Access Compliance Report

Public Rights-of-Way

(Curb Ramps)

Intersection ID: 11674	Main Street: HEARN_PL	Cross Street: N_GRAHAM_ST	Location: W
ADA ID: 28CC57D9B0C8	Ramp Type: Directional1	Initial Pass/Fail: Fail	Overall Compliance: No
Severity Score: 12.5			
Codes/Mitigation Info/Possible Solution		Field Measurements/Component Compliance

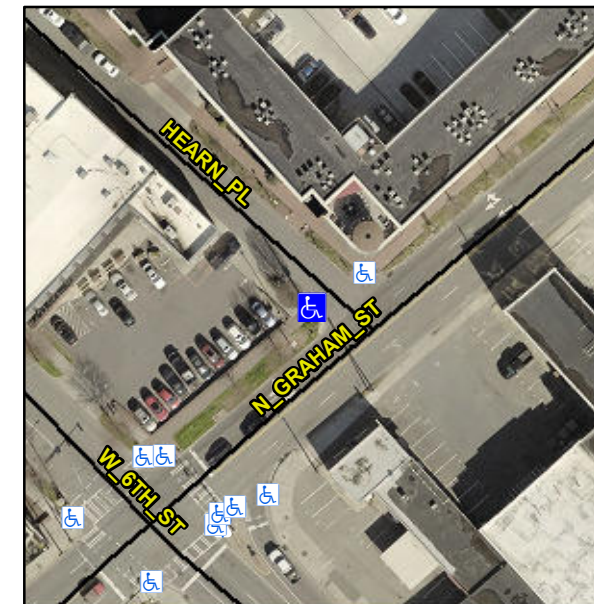
Remove & Replace Entire Ramp.

R304.2.2

Compliance	Description	Data	Compliance	Description	Data
N/A	Ramp Length (in)	34.0	N/A	Grade Break?	N/A
Yes	Ramp Width (in)	48.0	N/A	Grade Break Slope (%)	0.0
No	Ramp Slope (%)	10.9	N/A	Grade Break XSlope (%)	0.0
Yes	Ramp XSlope (%)	1.5			
N/A	Flare Type LT	N/A	N/A	Flare Type RT	N/A
N/A	Flare Slope LT (%)	N/A	N/A	Flare Slope RT (%)	0.0
N/A	Flare Traversable LT?	N/A	N/A	Flare Traversable RT?	N/A
N/A	Landing Length (in)	0.0	N/A	DWS Provided?	N/A
N/A	Landing Width (in)	0.0	N/A	DWS Contrast?	N/A
N/A	Landing Slope (%)	0.0	N/A	DWS Length (in)	N/A
N/A	Landing X Slope (%)	0.0	N/A	DWS Full Width?	N/A
N/A	Landing Curb? (Y/N)	N/A	N/A	DWS Offset LT (in)	N/A
N/A	Shared Landing?	N/A	N/A	DWS Offset RT (in)	N/A
N/A	Gutter Ponding?	0.0	N/A	Gutter Slope (%)	N/A
N/A	Gutter Lip Ht (in)	0.0	N/A	Gutter X Slope (%)	N/A
N/A	Painted X Walk1?	No		Road Slope (%)	5.8
	X Walk 1 Direction	To NE		Road X Slope (%)	2.3
	X Walk 1 Width (in)	N/A		Clear Space?	N/A
